TECHNICAL BULLETIN

LTB00463NAS1

Tailgate Window Glass Trim Panel Indentations

Range Rover Sport (LS)

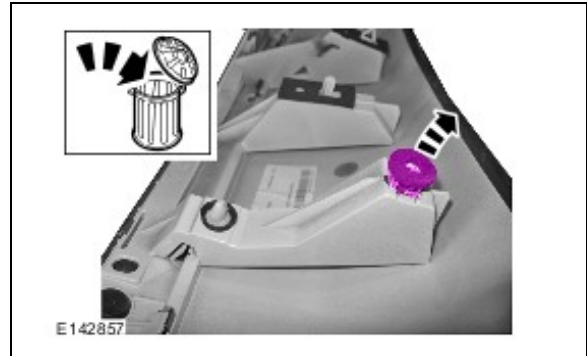
Situation: The rear tailgate window glass trim panel may appear to be uneven or to have indentations.

Cause: This may be caused by the trim panel fixings being over torqued.

1. Refer to Workshop Manual section 501-08 and remove the tailgate window glass trim panel.
2. Use a suitable tool to remove and discard the two fir tree clip inserts.

3. Install the two new fir tree clips.

4. Refer to Workshop Manual section 501-08 and install the tailgate window glass trim panel.
